Federal Register

[Docket No. FAA-2013-0023; Directorate Identifier 96-CE-072-AD]

Airworthiness Directives; Various Aircraft Equipped With Wing Lift Struts

ACTION: Notice of proposed rulemaking (NPRM).

Figure 1

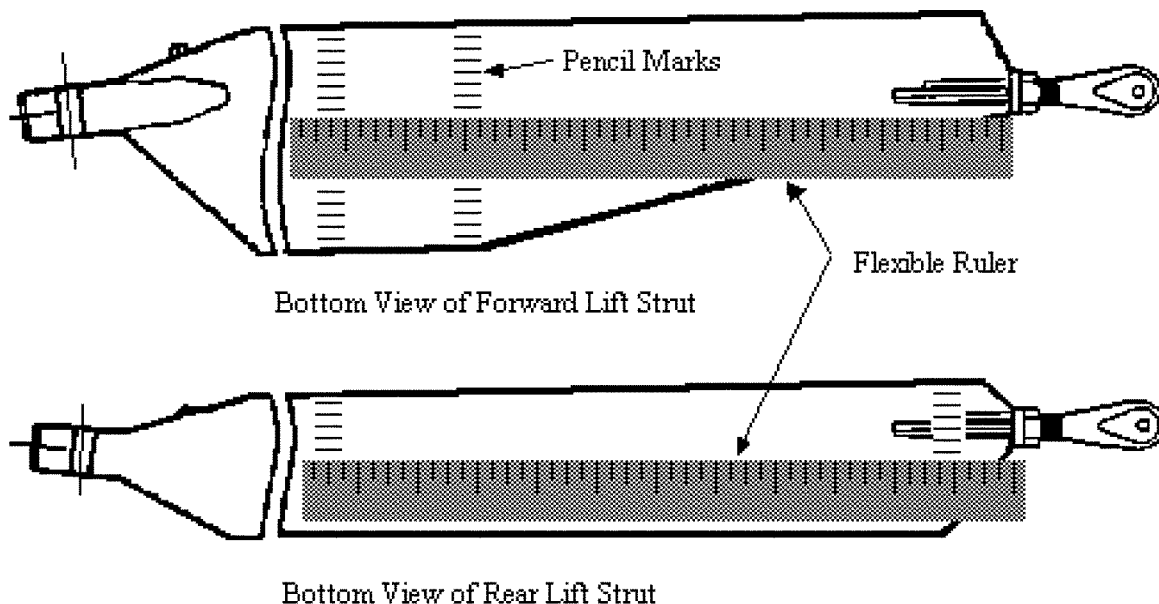
2. Using a flexible ruler, draw a 1/4-inch grid on the surface of the first 11 inches from the lower end of the strut as shown in Piper Service Bulletin No. 528D or 910A, as applicable. This can be done using a soft (#2) pencil and should be done on both faces of the strut. As an alternative to drawing a complete grid, make two rows of marks spaced every 1/4-inch across the width of the strut. One row of marks should be about 11 inches from the lower end of the strut, and the second row should be several inches away where the strut starts to narrow. Lay the flexible ruler between respective tick marks of the two rows and use tape or a rubber band to keep the ruler in place. See Figure 1.
